December 2017
FL724A-Q
NHTSA #16V-666 (Non-School Buses)
NHTSA #16V-664 (School Buses)
FOURTH REVISED NOTICE

Subject: ICU3S Instrument Cluster Hydraulic Brake Telltale

Models Affected: Specific Freightliner Business Class M2 vehicles and Freightliner Custom Chassis S2 bus and B2 (Thomas Built Buses C2 Saf-T-Liner) school bus chassis manufactured March 3, 2015, through September 8, 2016.

Fig. 1, A "Park" Telltale - Replace ICU3S

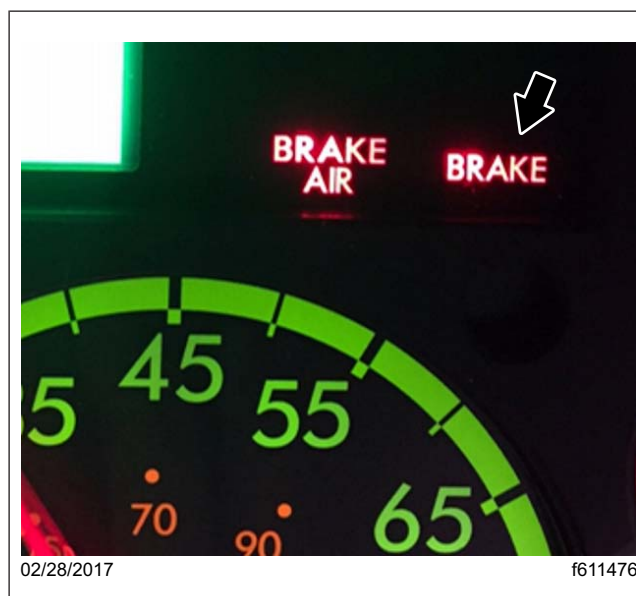
1. Check the base label (Form WAR259) for a completion sticker for FL724 (Form WAR260) indicating this work has been completed. The base label is usually located on the passenger-side door, about 12 inches (30 cm) below the door latch (trucks) or over the driver's window (buses). If a completion sticker is present, no work is needed. If a completion sticker is not present, proceed to the next step.
2. Park the vehicle, shut down the engine, and apply the parking brakes. Chock tires.
3. During the bulb check at key-on, inspect the telltales on the ICU3S (affected telltales will be illuminated for three seconds). See [Fig. 1](#) and [Fig. 2](#).

If the ICU3S has a "Park" telltale, continue with the next step.

The instrument clusters will be inspected and replaced with clusters displaying the correct warning as needed.
